Rezoning Transportation Analysis

Petition Number: 2019-141

Date	Description
11-13-19	First Review

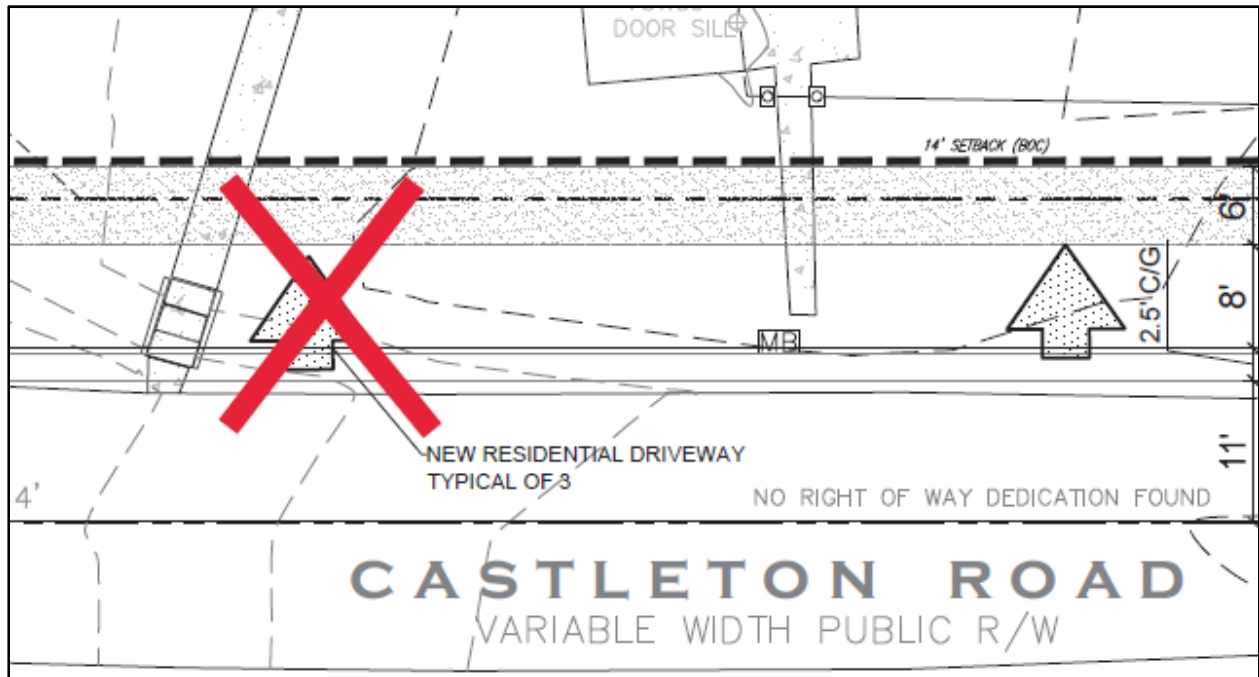
- Curbline** The proposed zoning district has a setback measured from back of the existing or proposed future curbline.
 - North Sharon Amity Road:** The future location of the curb and gutter should be measured 33' from the centerline of North Sharon Amity Road to include an 11-foot left turn lane, 2-11-foot travel lanes and 2.5' curb and gutter.
 - Castleton Road:** The future location of the curb and gutter should be measured 11' from the centerline of Castleton Road to include an 11-foot travel lane and 2.5' curb and gutter.

The site plan should show the curb and gutter labeled and dimensioned from the centerline for each road.
- Traffic Study** A Traffic Impact Study is not necessary for the complete review of this petition.

- North Sharon Amity Road is an existing major thoroughfare located outside Route 4 which requires a 100-foot right-of-way. The petitioner should revise the site plan and conditional note(s) to commit to dedicate 50-foot right-of-way from North Sharon Amity Road centerline. The site plan should label and dimension the right-of-way from the road centerline.

- North Sharon Amity Road has been identified on the High Injury Network due to a serious injury crash. The petitioner should revise the site plan and conditional note(s) to include a northbound left turn lane onto Castleton Road.

- The proposed Urban Residential zoning requires an updated streetscape along North Sharon Amity Road. The petitioner should update the site plan to commit to construct an 8-foot planting strip and 6-foot sidewalk to comply with the North Sharon Amity Road Sidewalk Improvements Capital Improvement Plan.

- The petitioner should revise the site plan and conditional note(s) to eliminate the driveway closest to the intersection of North Sharon Amity Road and Castleton Road. Due to the proximity of the proposed driveway to the existing intersection at Castleton Road and North Sharon Amity Road, CDOT will not allow this access point.
